CW3 PROJECT NUMBER 20-0016A
LEE COUNTY PROJECT NUMBER CN200224JJB

ORANGE RIVER BLVD. SIDEWALK
AND WATERMAIN REPLACEMENT

LEE COUNTY PROJECT NUMBER CN200224JJB
LUMEN PROJECT #P.043315
ORANGE RIVER BLVD SIDEWALK AND WATERMAIN REPLACEMENT - LEE COUNTY
CENTURYLINK-LUMEN CONSTRUCTION PLANS
UTILITY PLAN

C.1
SHT 4 OF 14

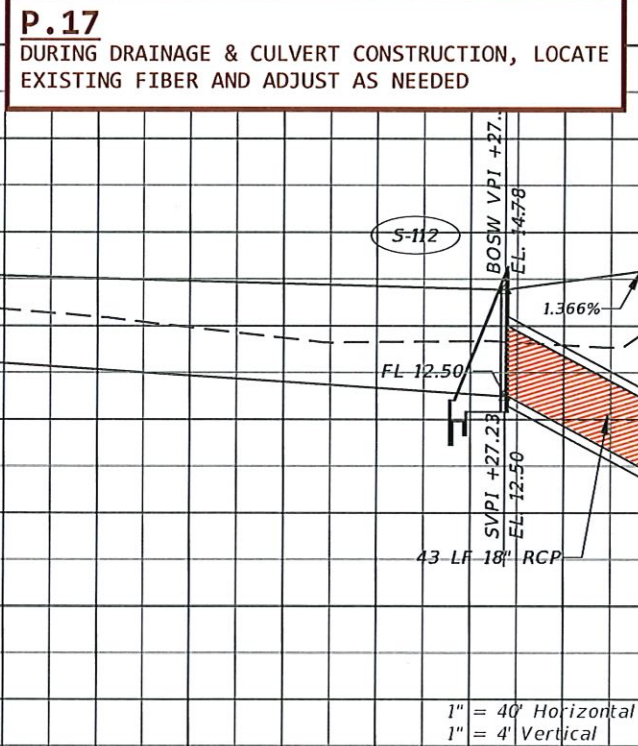
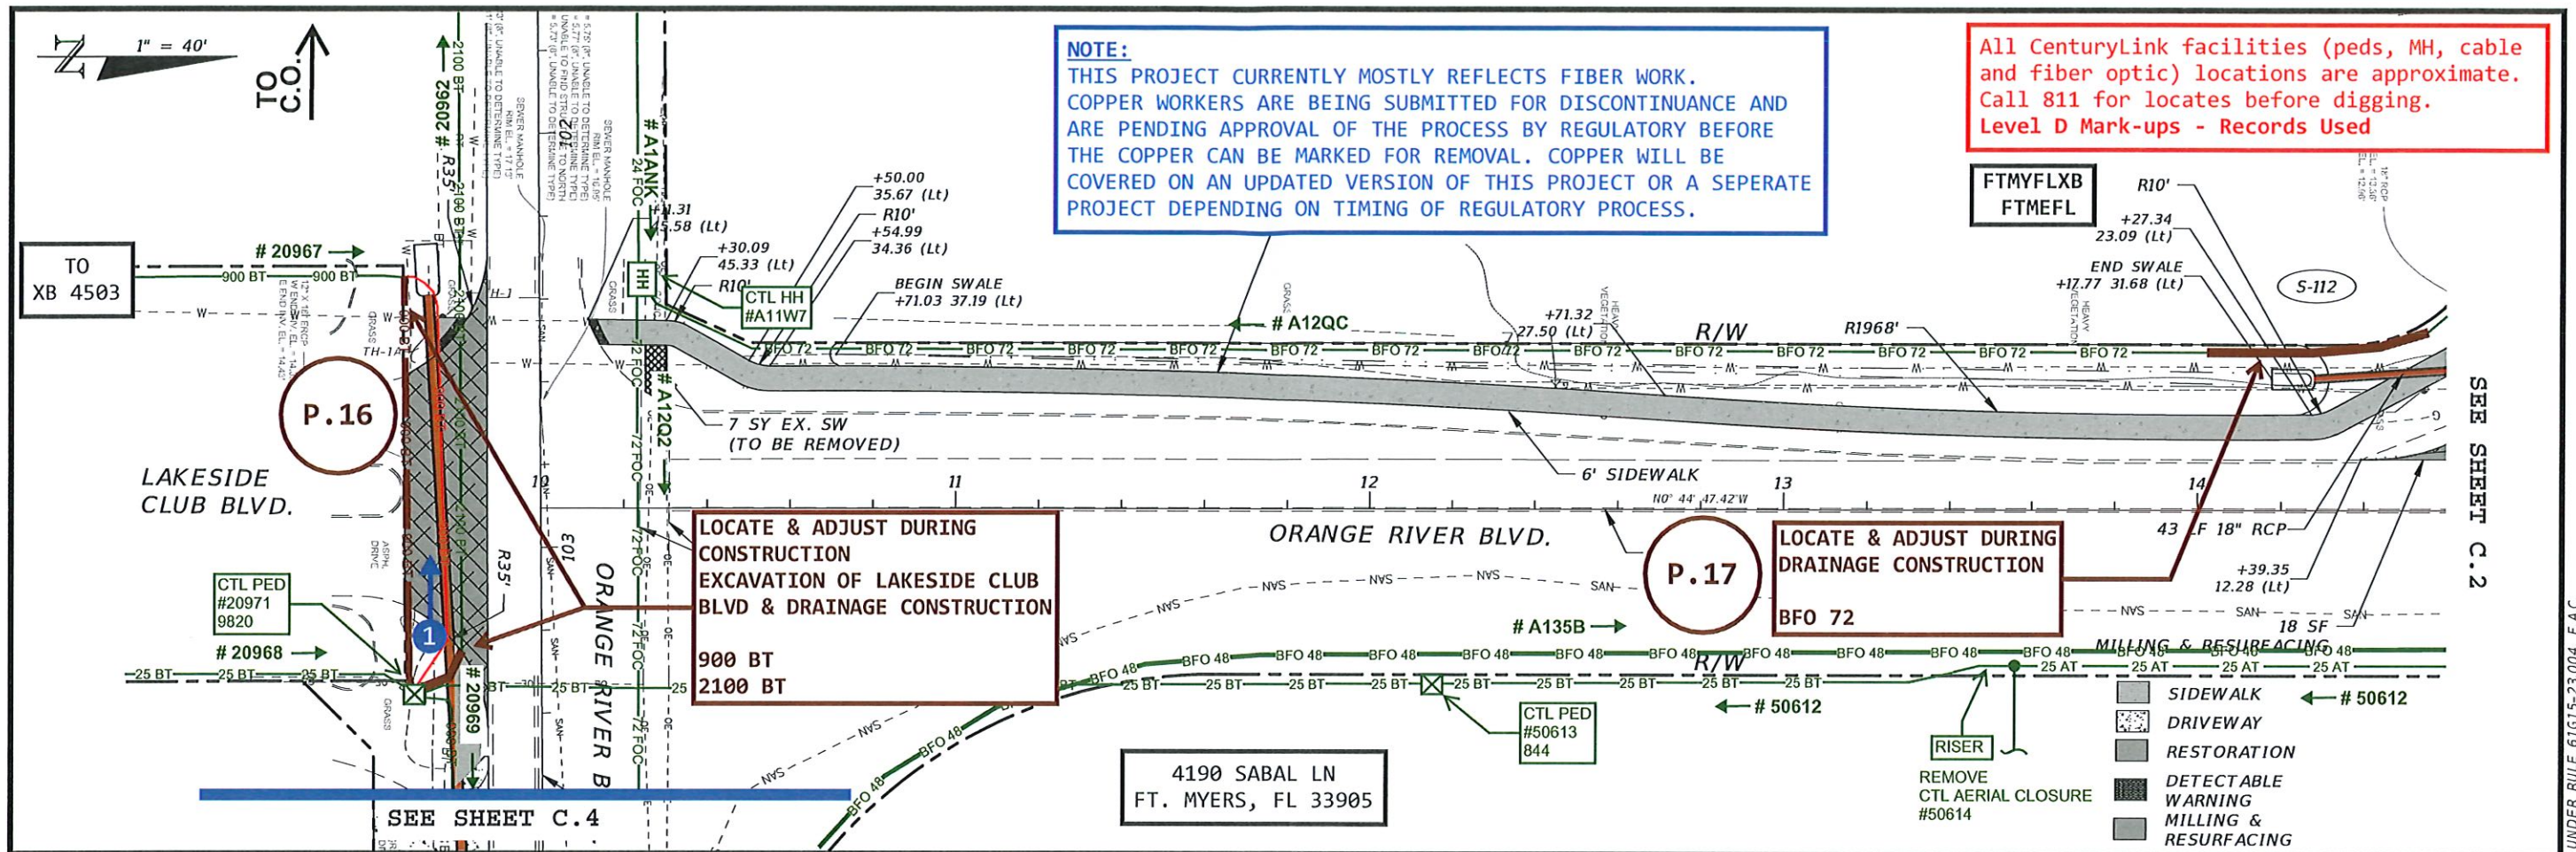
P.16
DURING ROAD CONSTRUCTION ON LAKESIDE CLUB BLVD FOR NEW DRAINAGE, ADJUST 900 BT TO REAR OF ROW TO PRESERVE CABLE.

LOCATE & PROTECT/ADJUST 2100 BT DURING THE SAME CONSTRUCTION EFFORT.

COPPER CABLE TO EAST OF OF PED #20971 HAS BEEN SUBMITTED FOR DISCONTINUANCE.

THE 900 BT ON LAKESIDE CLUB BLVD FEEDS XB 4503 AND INCLUDES POTS, HSI, AND SPC CKT.

LAKESIDE CLUB BLVD IS A PRIVATE ROADWAY WITHOUT AN EXISTING EASEMENT ON RECORD AND SO WE CANNOT PLACE NEW FACILITIES WITHIN ITS BOUNDS.

INSTEAD WE MUST ADJUST THE EXISTING CABLE AS POSSIBLE AND WILL NEED TO COORDINATE WITH THE ROAD CONSTRUCTION EFFORTS WHEN THEY REMOVE A PORTION OF PAVEMENT FOR THEIR DRAINAGE WORK WE CAN THEN MOVE OUR CABLES.

SOME LOCATE & ADJUST MAY BE REQUIRED IF THEIR EXCAVATION DOES NOT EXPOSE ALL AREAS OF THE CABLE THAT REQUIRE ADJUSTMENT.

C.2

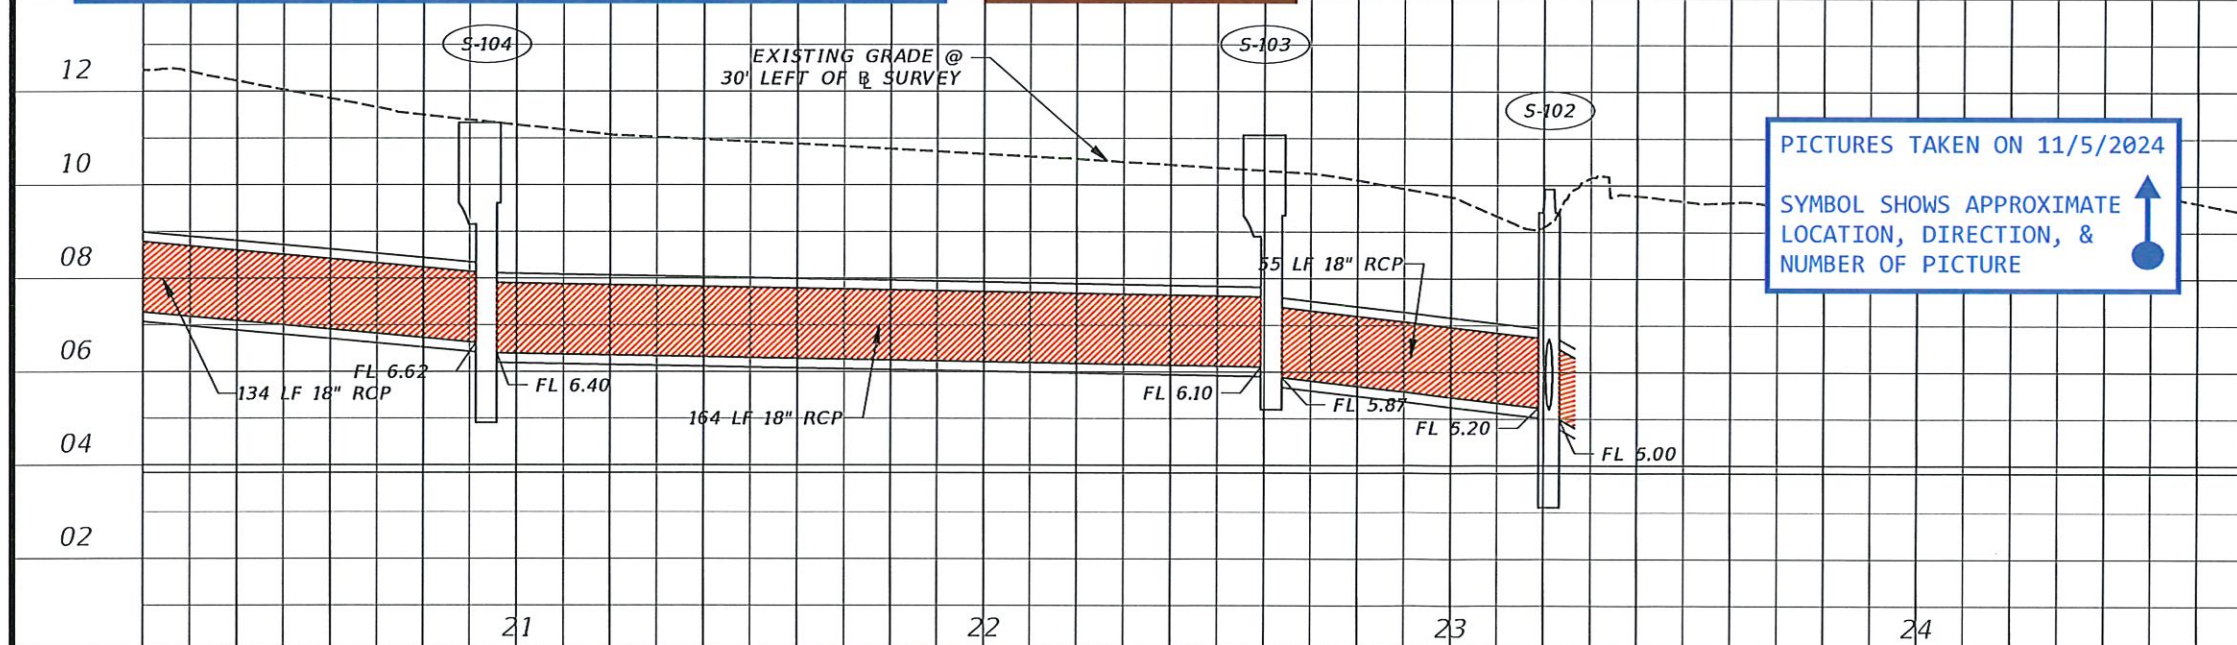
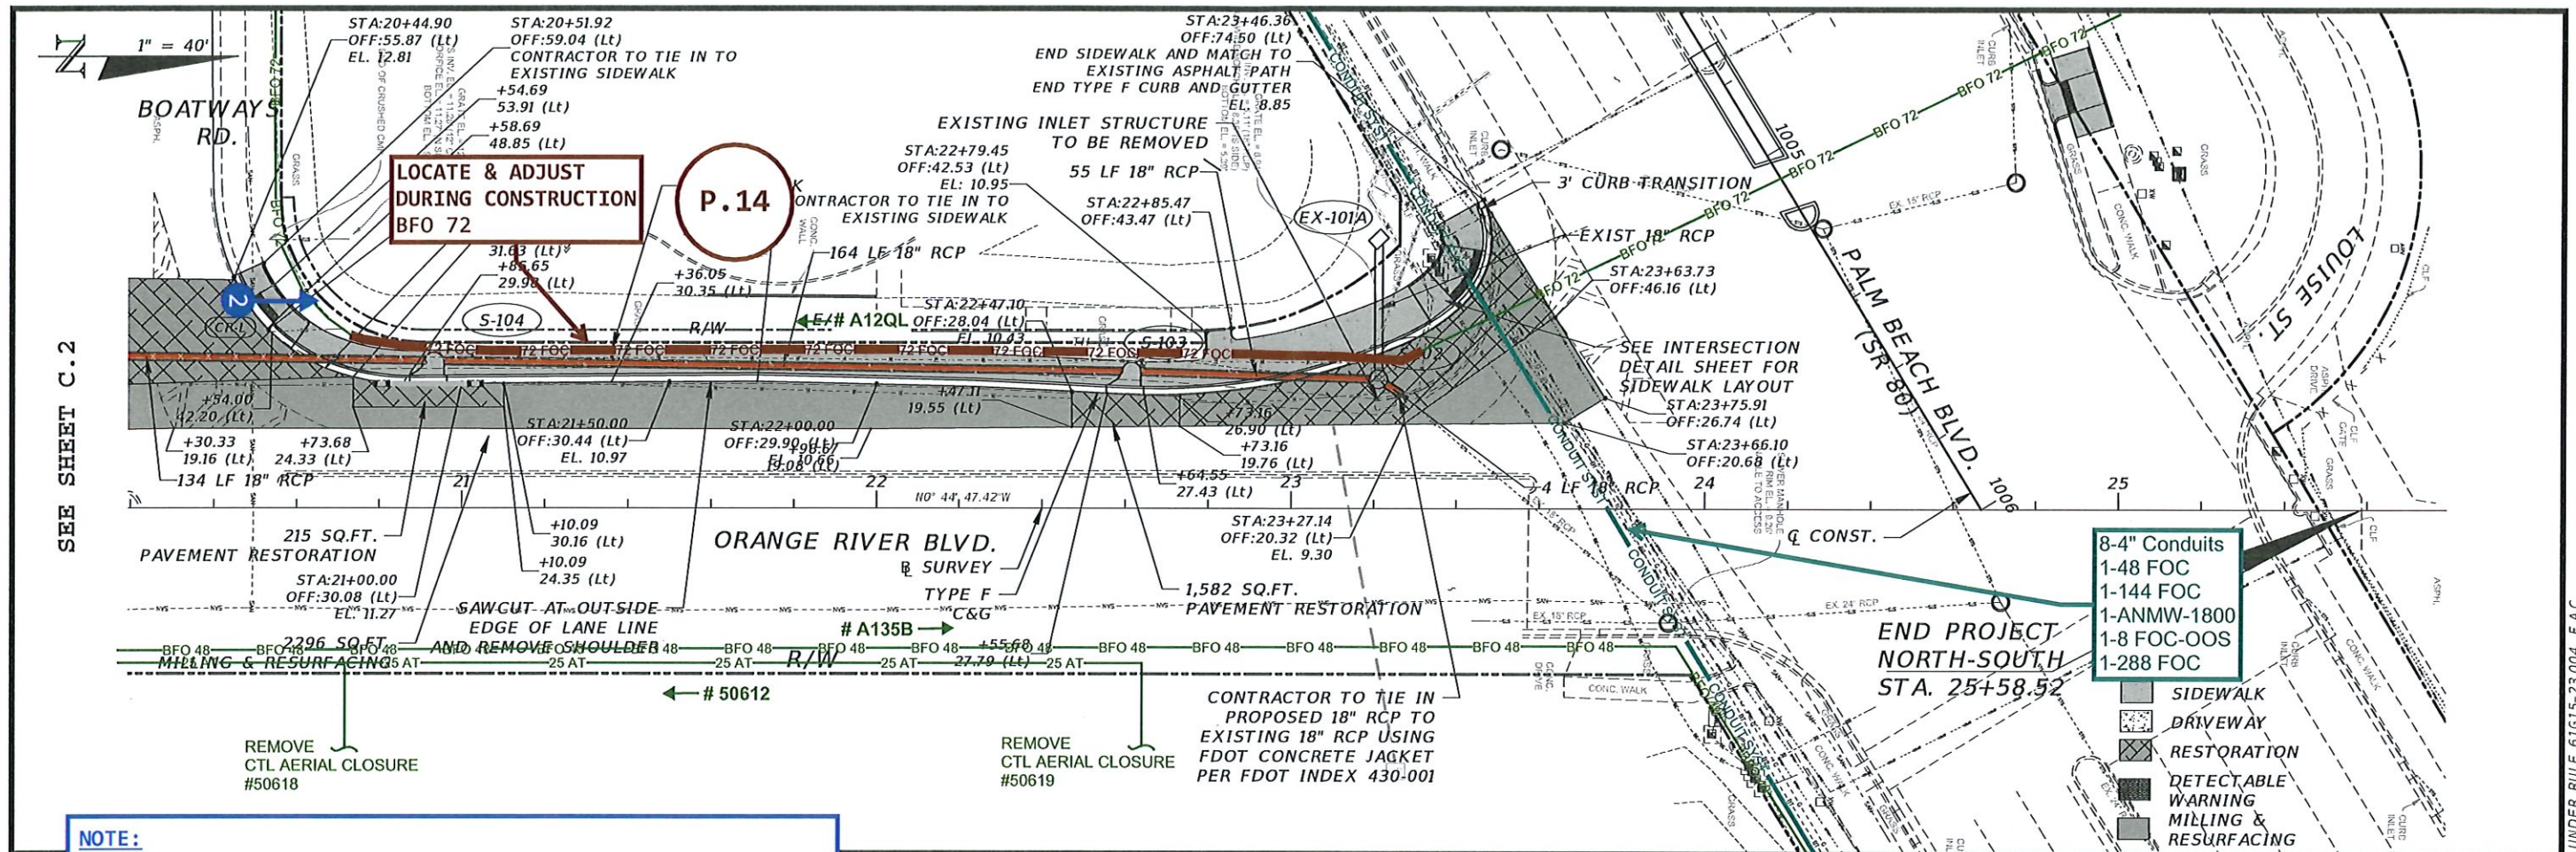
P.14
 LOCATE & ADJUST DURING CONSTRUCTION
 BFO 72

C.7
SHT 12
OF 14

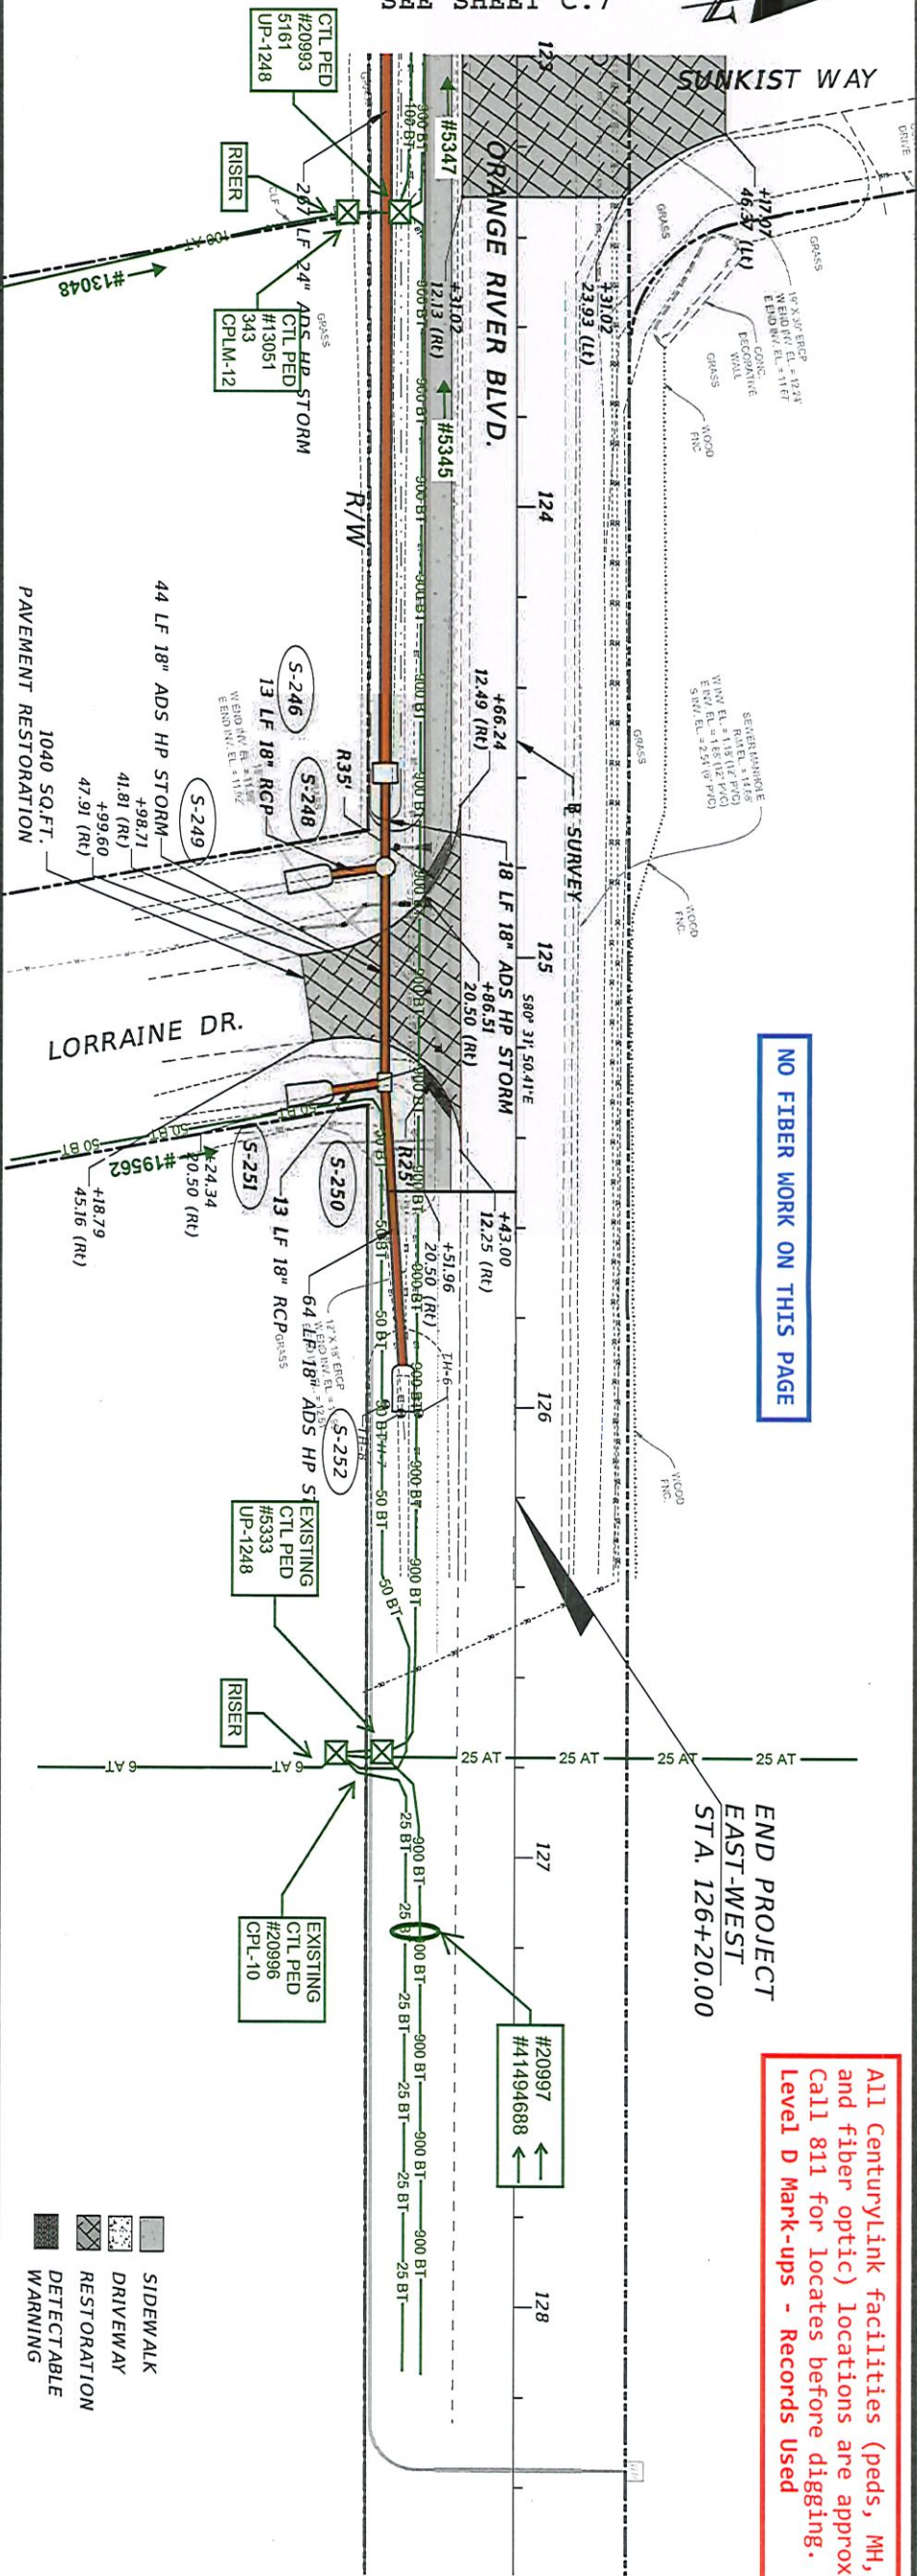
LOCATE & ADJUST AS REQUIRED
DURING DRAINAGE CONSTRUCTION

P.13
LOCATE & ADJUST DURING
CONSTRUCTION OF NEW DRAINAGE

**LOCATE & ADJUST DURING
CONSTRUCTION OF NEW DRAINAGE**
